# CABINET MEMBER FOR ENVIRONMENT – 12 JANUARY 2017

# PROPOSED SPEED LIMIT CHANGE - B4017 ABINGDON ROAD, DRAYTON

#### Report by Interim Deputy Director of Environment & Economy (Commercial)

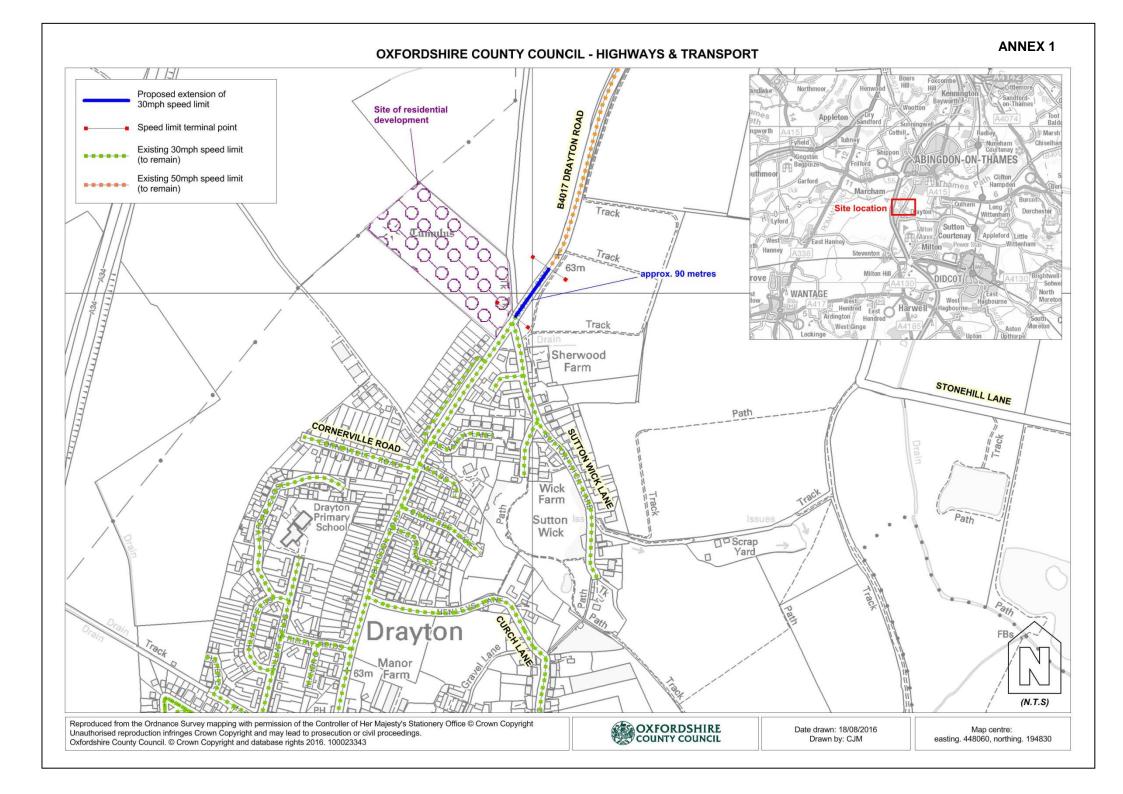
RESPONDENT	SUMMARISED COMMENTS
(1) Thames Valley Police	<ul> <li>Objects – with the following comments:</li> <li>Having visited the location yesterday the new junction is already situated within the existing 30mph speed limit and I see no justification to extend this speed limit any further into open countryside.</li> <li>The new junction is also on the village side of the Sutton Wick lane junction.</li> <li>Any extension to the existing speed limit could also weaken the current Drayton speed limit resulting in further calls for police enforcement.</li> <li>Unless there is additional justification/evidence why this speed limit should be extended, I object to the current proposal.</li> </ul>

(2) Drayton Parish Council	<ul> <li>Supports – with the following comments:</li> <li>Feels that the proposed speed limit should be extended further out, with consideration of a 30mph speed limit being introduced on the entire length of the road between Drayton and Abingdon.</li> </ul>

(3) Resident (Marston, Oxford)	<ul> <li>Supports – with the following comments:</li> <li>Given that it's a shared road for cycling and motor vehicles, the speed limit should be reduced to 20mph and extended all the way to Abingdon, but obviously any stricter limit is a step in the right direction.</li> <li>I therefore support the proposal even though it absolutely insufficient.</li> </ul>

- 10. The Cabinet Member for the Environment is RECOMMENDED to:-
  - (a) not approve the proposals to extend the speed limit as advertised; and
  - (b) instruct officers to consult on a revised proposal to introduce a 40mph limit in place of the existing 50mph limit between Drayton and Abingdon.
